**RE: Flare KOD Pump Sodium Hydroxide Release Investigation Work Plan  
Western Refining Southwest Inc., Gallup Refinery  
EPA ID #NMD000333211  
HWB-WRG-20-003**

**MARATHON PETROLEUM CORPORATION**  
**GALLUP REFINING DIVISION**  
**FLARE KOD PUMP CAUSTIC RELEASE**  
**SOIL SAMPLING INVESTIGATION WORK PLAN**  
**NOVEMBER 30, 2020**

RE: Response to Approval with Modifications  
Response Action Report Flare KOD Pump Sodium Hydroxide Release  
Western Refining Southwest Inc., Gallup Refinery  
EPA ID #NMD000333211  
HWB-WRG-20-003

**FIGURE 4**

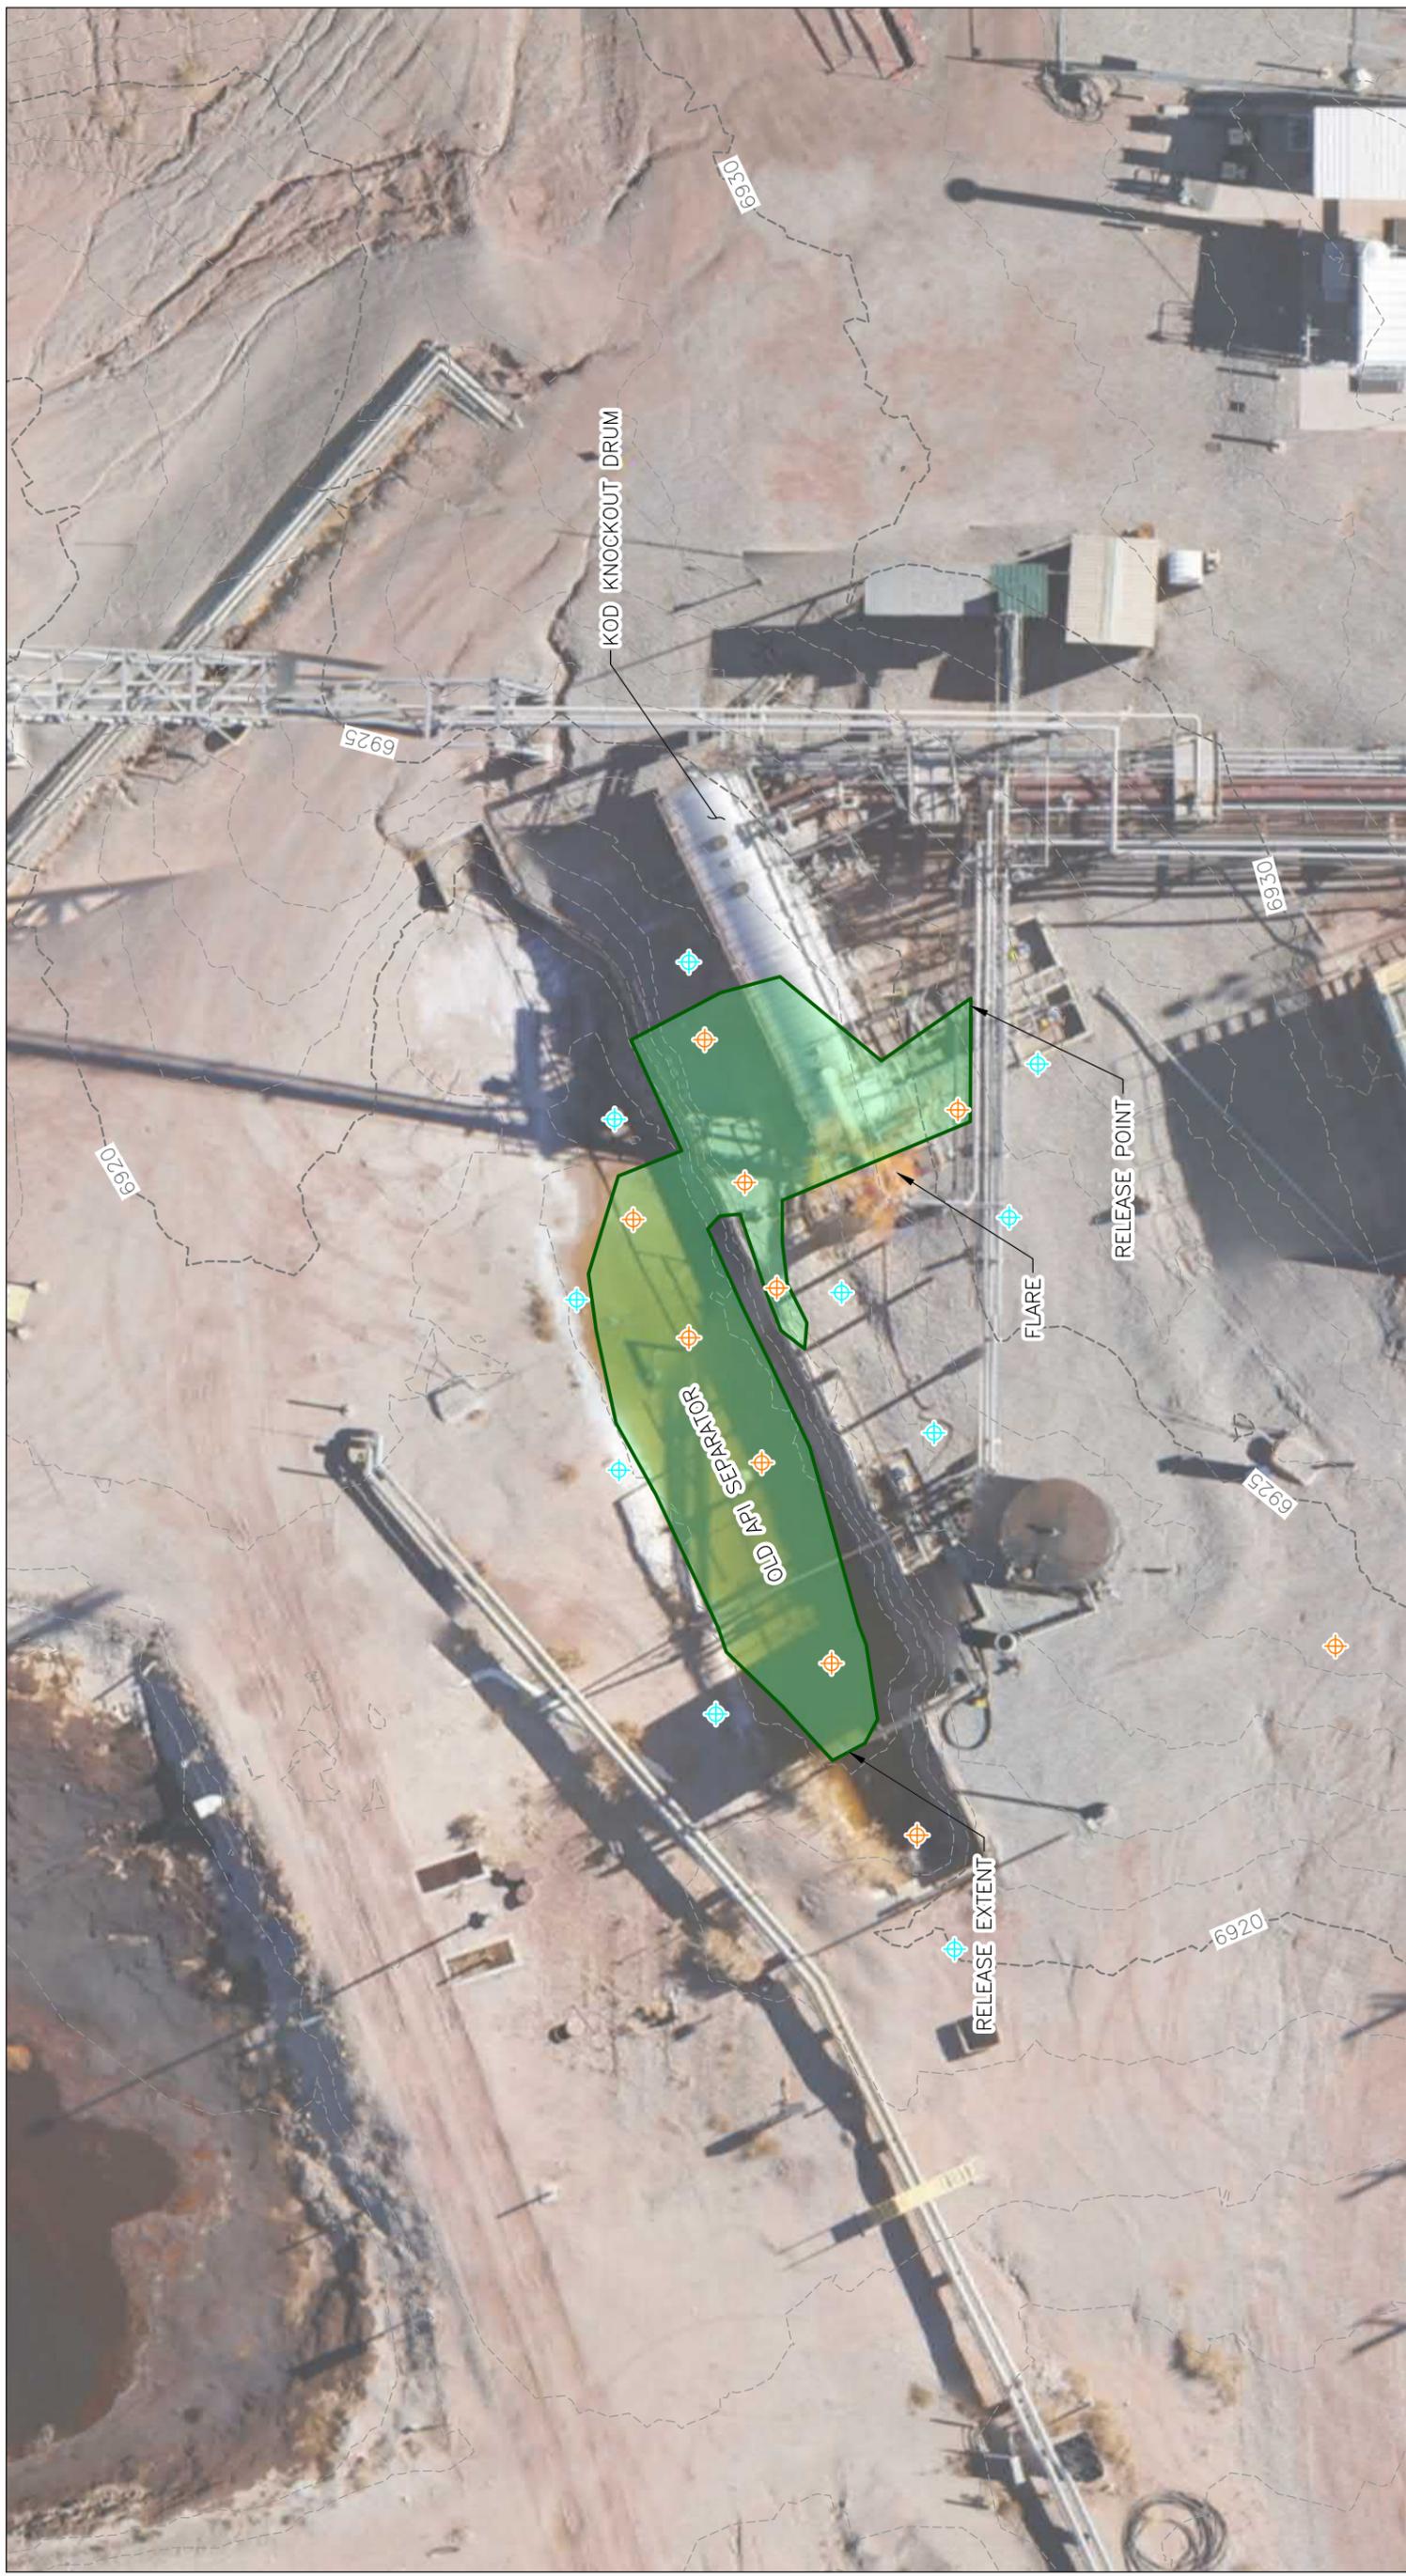
Several soil samples in the release footprint will be collected to a depth of one foot below ground surface and analyzed for pH and gasoline range (GRO) and diesel range organics (DRO) total petroleum hydrocarbons (TPH) (Figure 4). Because the caustic could have contained some amount of TPH-GRO and TPH-DRO, the analysis will help delineate the footprint of the spill and the potential contamination of caustic and hydrocarbons. To help delineate the extent of the caustic infiltration, soil pH values will also be

In the Conclusions and Recommendations Section, *Recommended Additional Excavation and Assessment*, page 6 of 6, the Permittee states, “several soil samples in the release footprint should be collected to a depth of one foot below ground surface and analyzed for pH (Figure 4). An additional soil sample collected from the same depth should also be collected outside the footprint of the release to establish a background pH for near surface soils.” A work plan must be submitted no later than **July 31, 2020** as specified by Comment 5. Each sample location depicted in Figure 4 must target topographically low areas where the released caustic would have likely accumulated. Revise the figure, as appropriate, and provide a revised figure with the response letter. In addition, since the caustic could have contained hydrocarbons, soil samples must be collected for the analysis of total petroleum hydrocarbons (TPH) as well as pH. Furthermore, soil pH may qualitatively be determined during field investigation. If pH values at a depth of one foot below ground surface (bgs) exceed 12.5, further investigation is warranted of deeper soils (e.g., at two feet bgs) to evaluate the vertical extent of contamination. Revise the statement and provide a replacement page.

A replacement page and a revised figure have been included as an attachment to this letter.

Depending upon the field results of the initial round of soil samples, soil samples at additional horizontal step-out locations will be collected at a depth of 1-ft bgs if the original sample has a pH greater than 12.5. These additional soil samples will be collected at downslope locations (Figure 4) outside of the original spill footprint at 5-foot horizontal intervals.
